## **Conceptual Review Agenda**

Schedule for 10/27/14 to 10/27/14

# **Vine Alternative Vehicle Fueling Facility**

**Description of project:** This is a request to build a compressed natural gas and electric vehicle fueling station. The applicant has four potential sites in mind for locating the fueling facility that comprise the following parcels: 9701300062, 9701308001, 9701306001, 9701306002, 9701300029, 9701463901 and 9712115901. The fueling station will be public access and will operate 24/7. The potential sites are located in the Community Commercial - North College (CCN) and Industrial (I) zone districts. This project will be subject to Administrative (Type I) review in the I zone district and Planning & Zoning Board (Type II) review in the CCN zone district.

Private Property, 300-500 E. Vine Drive, Fort Collins, Colorado

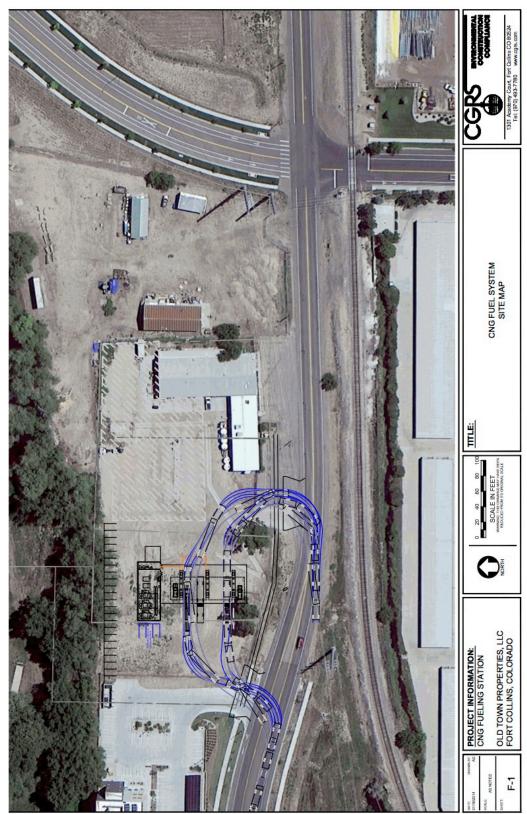
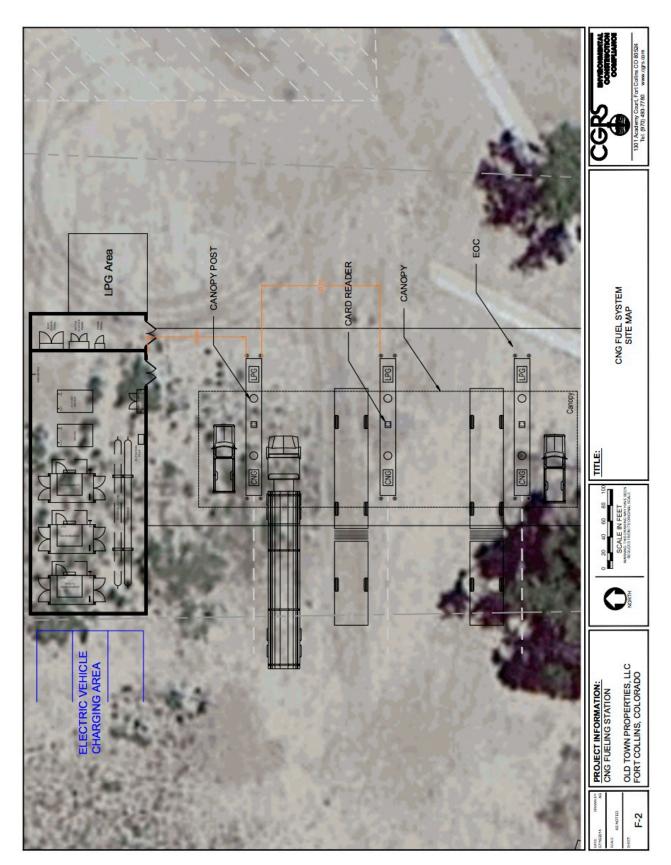
- 1. The use will be considered a "gasoline station," despite the semantics being out of date.
- Zoning does not permit the use on the 300-500 and 520 E Vine sites. (Community Commercial-North College, C-C-N). The zoning reflects a deliberate long term community plan for the area to transition from industrial uses to a creative innovation campus and the use would conflict with this long term plan. These sites are not suitable from staff's perspective.

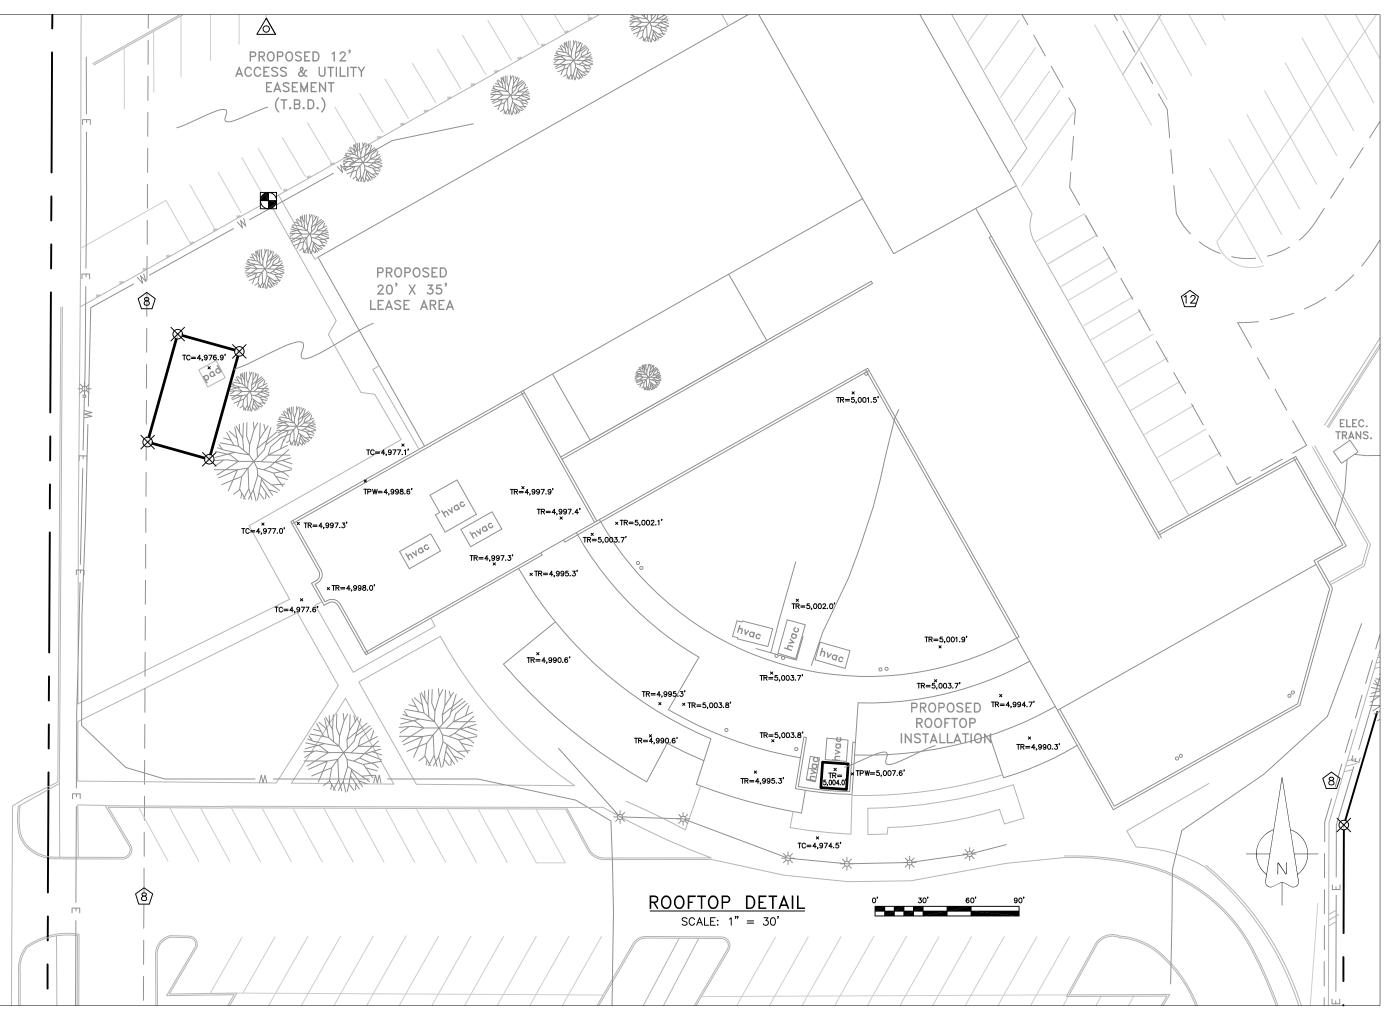
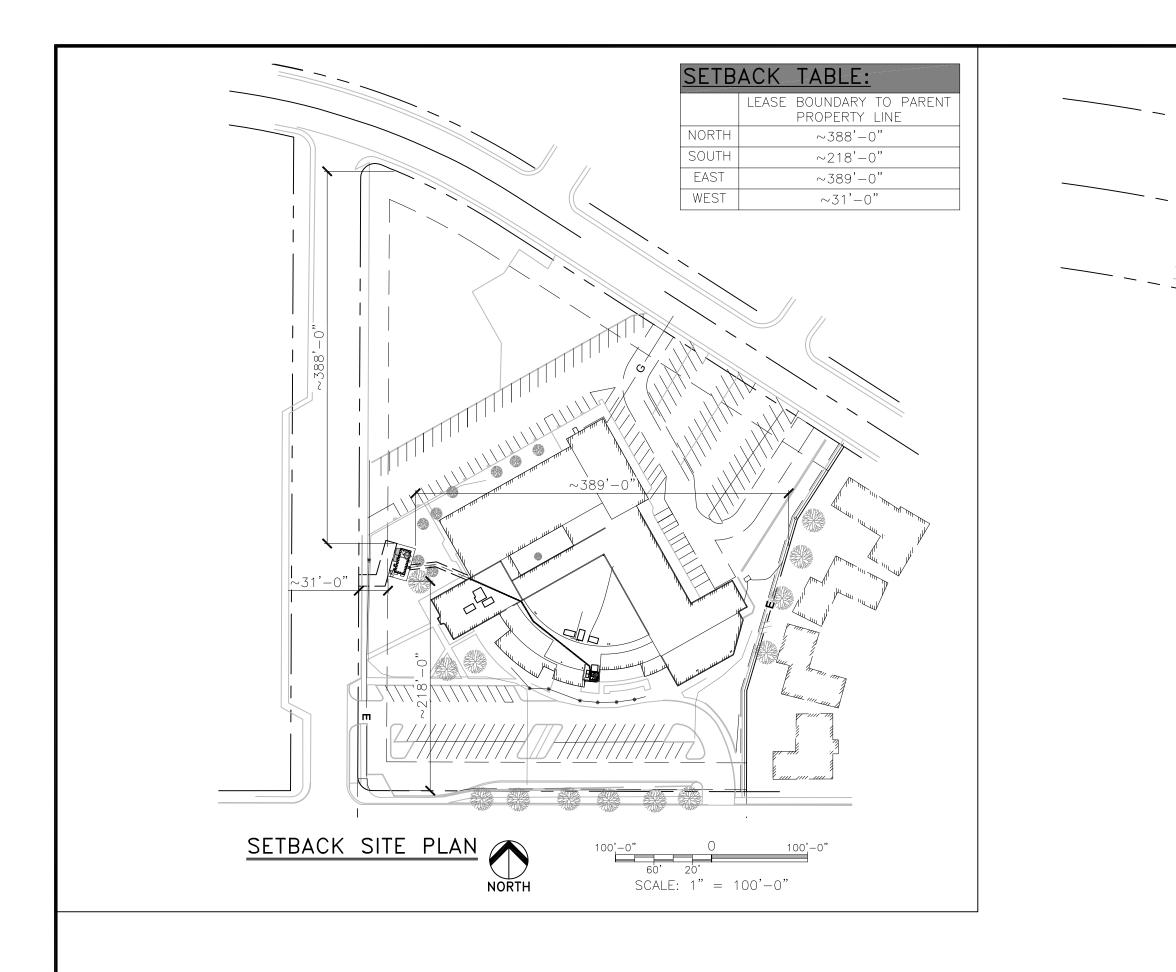
- 1. The plans for the equipment shelter show an access easement from Ellis Street. Is this planned as an access road? If so, staff would recommend orienting the shelter so that access can be taken from the existing parking lot to the north.

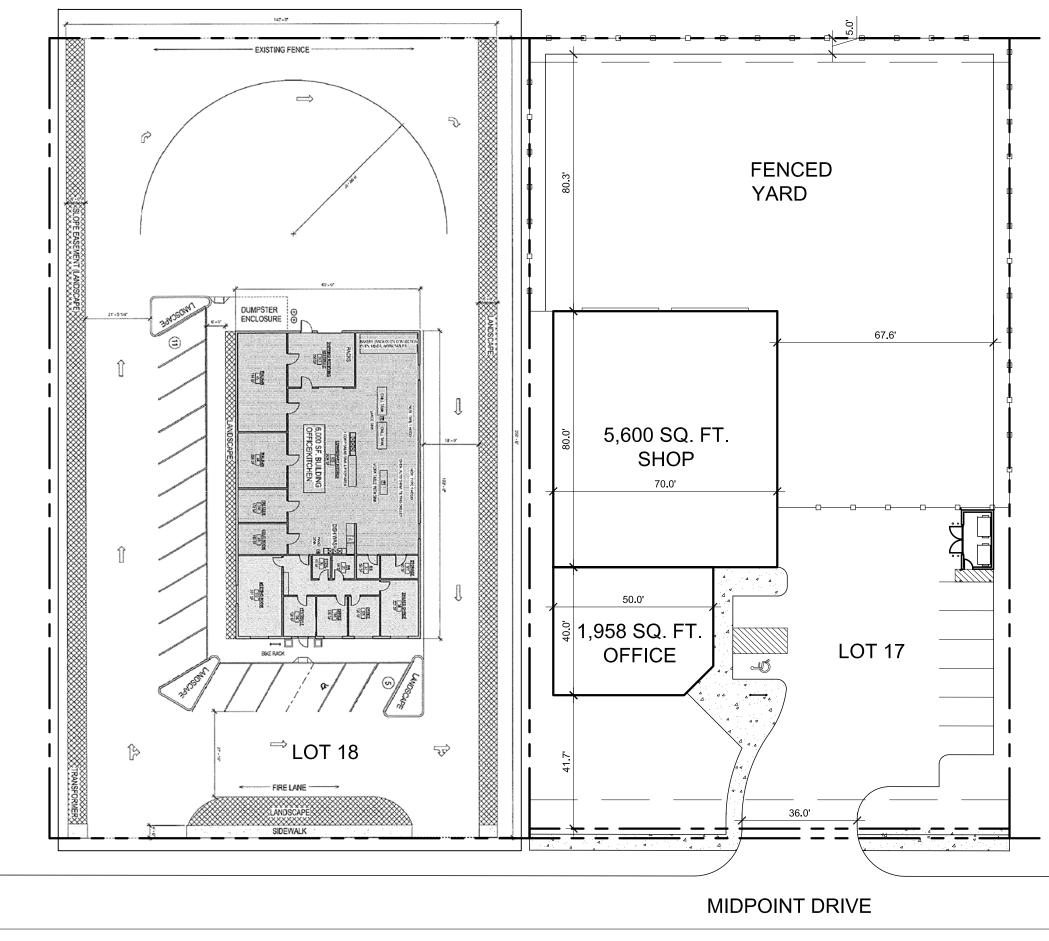
- 1. 3.2.1 The site plan does not show any landscaping on the interior or boundary of the parking lot. 6% of the interior area of the parking lot needs to be landscaped and the parking lot needs to be screened from abutting land uses via landscaping.

- **6.** Please clearly indicate the location of the fence on the final site plan. I assume it is indicated by the lines with squares but that is unclear without labels.
